TECHNICAL BULLETIN

No: P045
Issue: 1
Date: 22 July 2008

RECALL: Rotary Coupler Wiring Fracture

LR3 (LA)	VIN:	5A309377 - 6A376426
	Model Year:	2005 - 2006
Range Rover Sport (LS)	VIN:	6A900290 - 6A939921
	Model Year:	2006

Figure 4

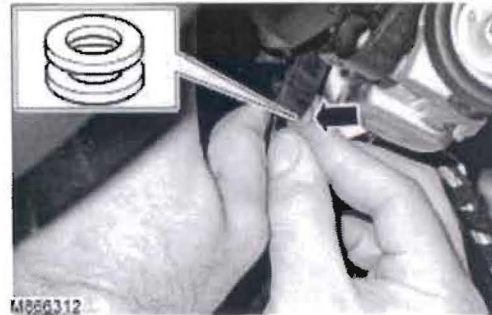
10. Insert two washers (**WC105002**) between the multi-function switch assembly fourth fixing point and column lock. (Figure 4)

Figure 7

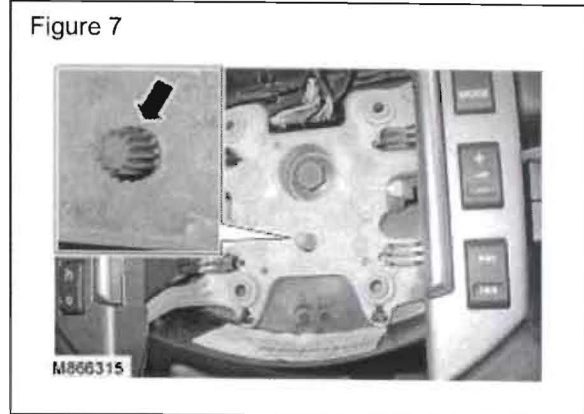
1. Refer to Workshop Manual (GTR) section 501-20B: Supplemental Restraint System (76.40.01) to remove the driver airbag module.
2. Rotate steering wheel to verify rotary coupler part number:
 - If rotary coupler part number **YRC500060** is fitted, replace the cylindrical drive peg sleeve with the ribbed sleeve provided in the kit, ensuring the sleeve is fully seated. (Figure 7)
 - If rotary coupler part number **YRC500060** is *not* fitted, continue to step 3
3. Refer to Workshop Manual (GTR) section 501-20B: Supplemental Restraint System (76.40.01) to install the driver's airbag module.

Figure 10

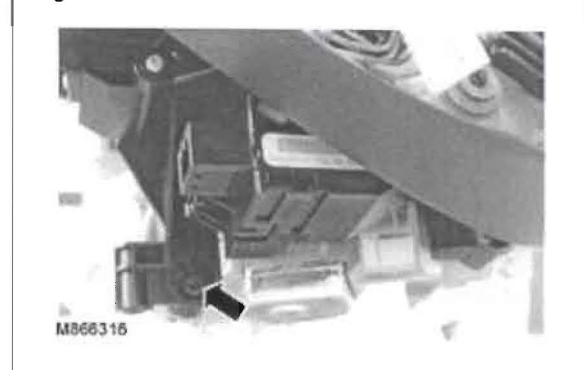
8. Rotate steering wheel for access as necessary.
9. Remove and discard the multi-function switch assembly's fourth fixing M5 x 14mm long screw (FYP500250). (Figure 10)

Figure 11

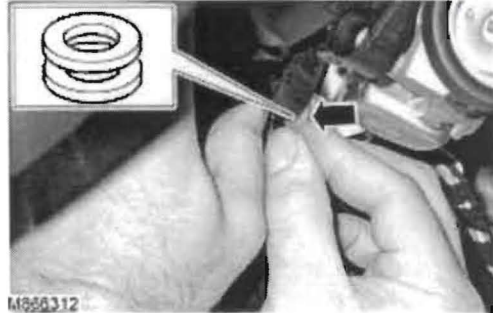
10. Insert two washers (**WC105002**) between the multi-function switch assembly fourth fixing point and column lock. (Figure 11)
